2 October 2024

SLR Ref No.: 630.031822.00001-v2-SEE-361 Oxley Highway, Gilgandra_CB_MD_.docx

RE: Statement of Environmental Effects
s4.55(1A) Modification to DA2021/430
361 Oxley Highway Gilgandra NSW 2827

Figure 1 Endorsed Site Plan Extract

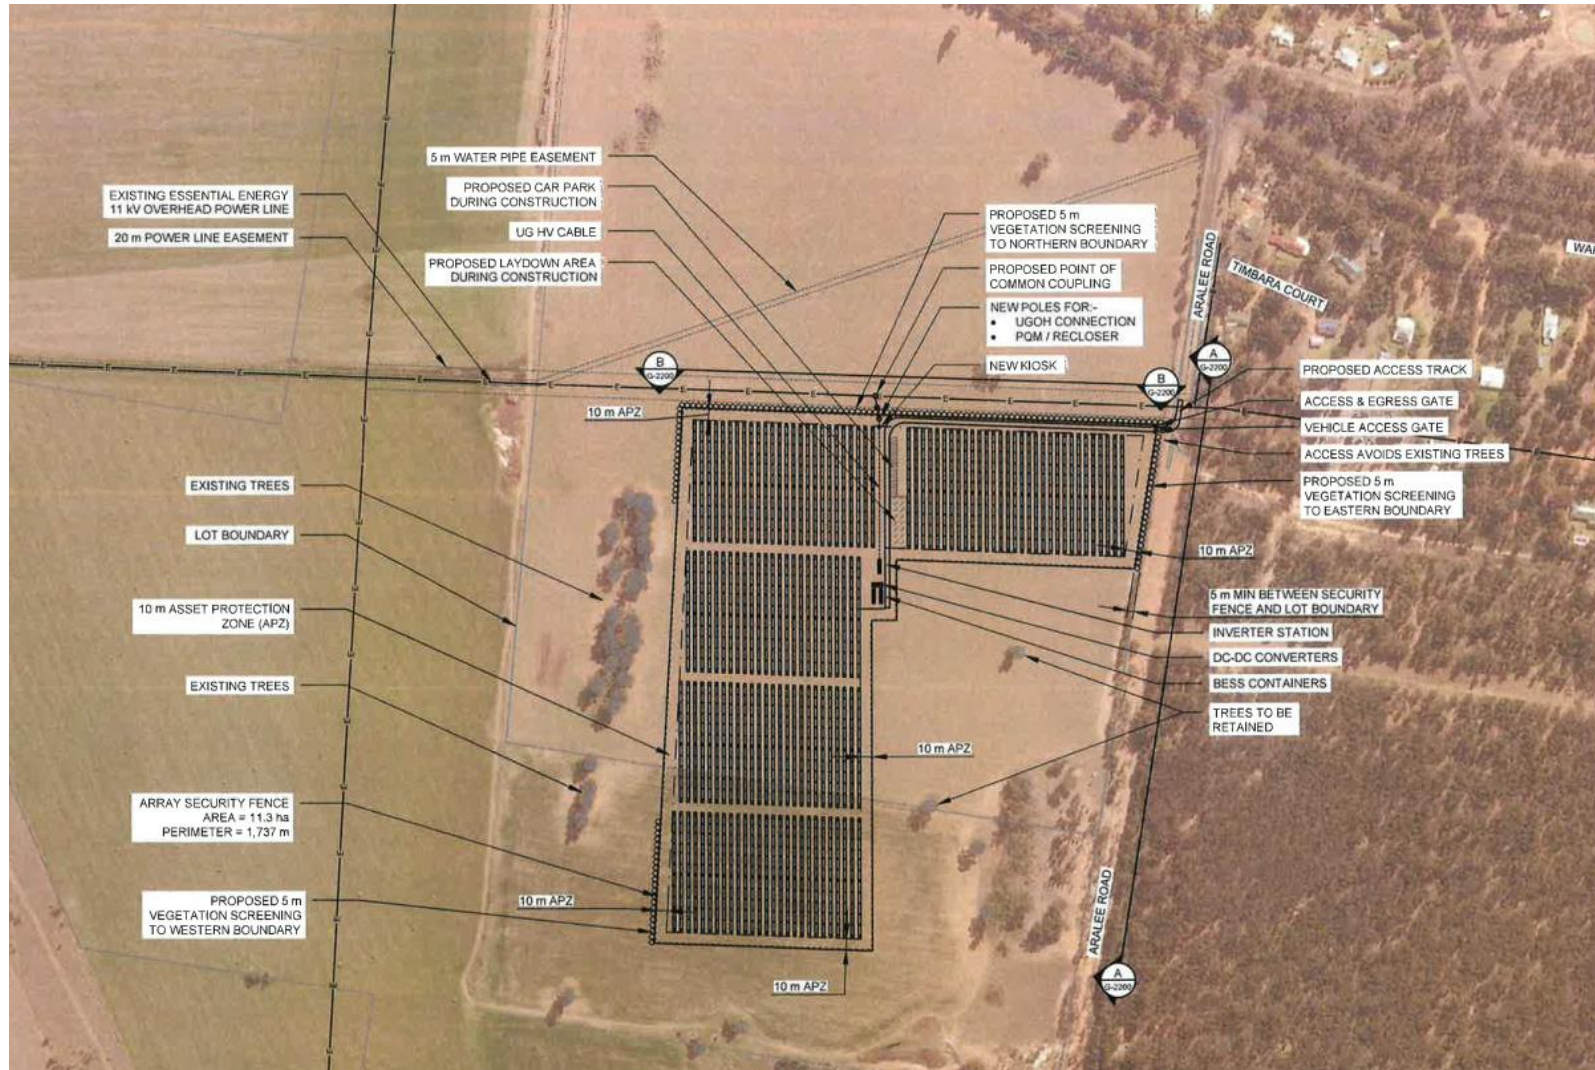
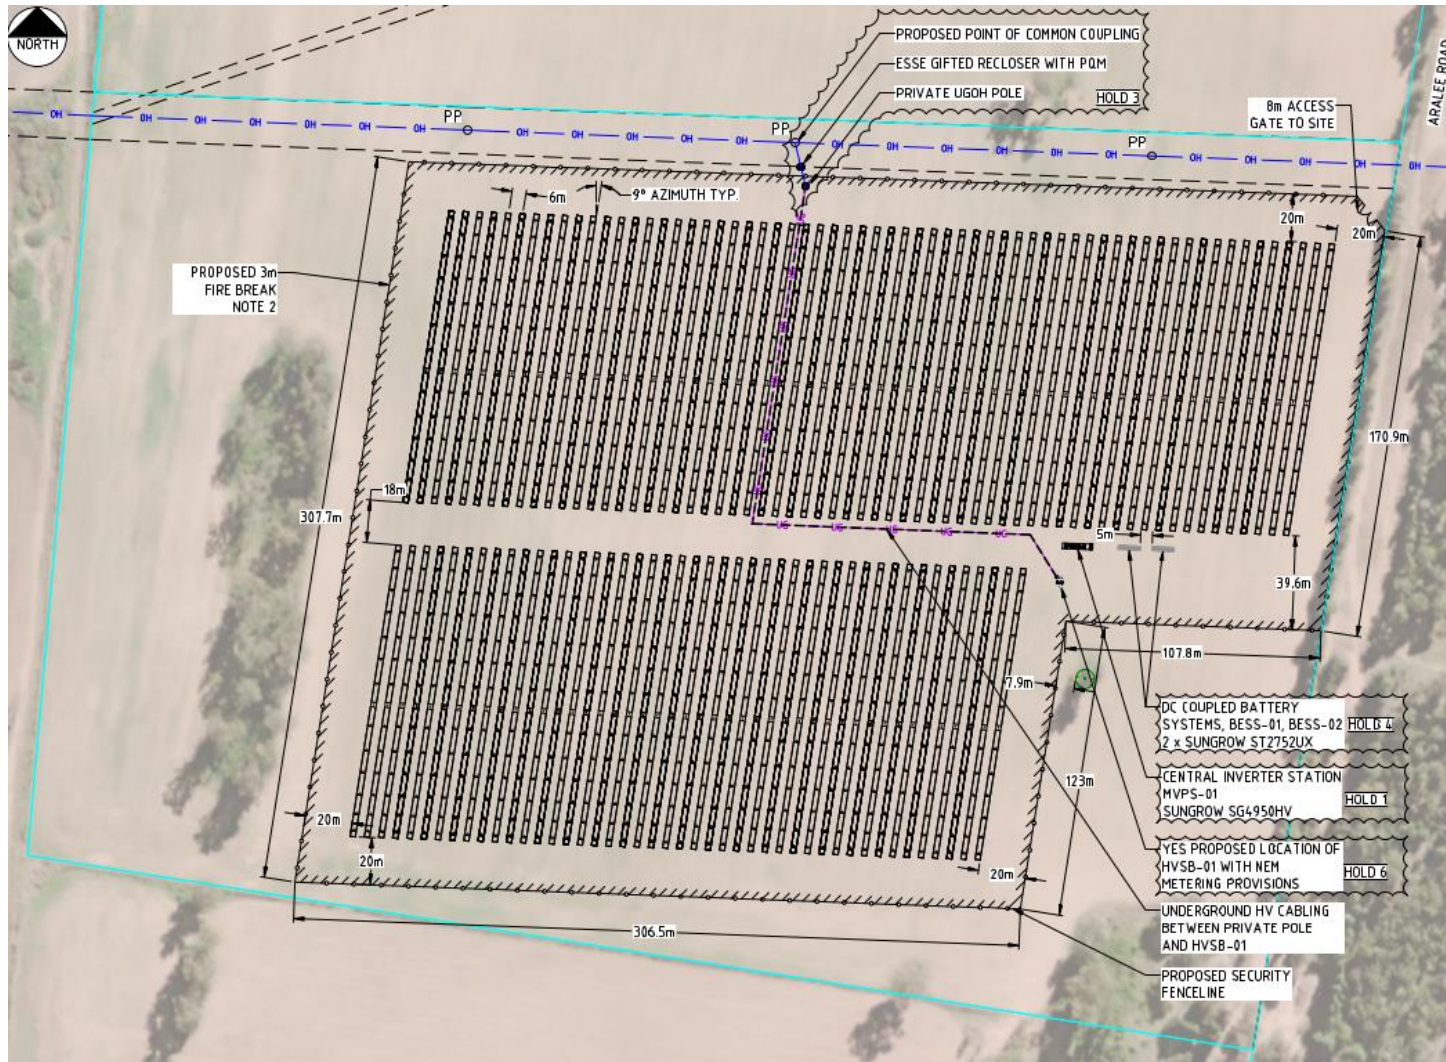
The proposed amendments to the approved DA2021/430 includes updates to the stamped plans. This modification application involves minor alterations to the approved layout of the proposed Solar Farm including:

APPROVED	PROPOSED
<ul style="list-style-type: none"> • 11.3ha fenced area; • 2 x 3.4 MW AC inverters; • 10m setback from bushfire zone; • 12,000 solar modules; and • Two (2) Battery Energy Storage System. 	<ul style="list-style-type: none"> • 11.34ha fenced area • 2 x 4.72 MW inverters • 20m setback from bushfire zone • 11,232 solar modules • Two (2) Battery Energy Storage Systems • Relocation of BESS; • Relocation of security fence around boundary; and, • No additional tree removal or access changes.

Refer to **Figure 1** and **Figure 2** for the endorsed and proposed site layout changes.

- Site layout changes resulting in reduction into a single Lot, retaining viable farming land to the south;
- Change in technology in panels has reduced modules and piling required without a reduction in output;
- Increase to 20m Asset Protection Zone (APZ); and,
- Modified entry to ensure compliance with Condition 22 of DA2021/430.

Figure 2 Proposed Site Plan Extract
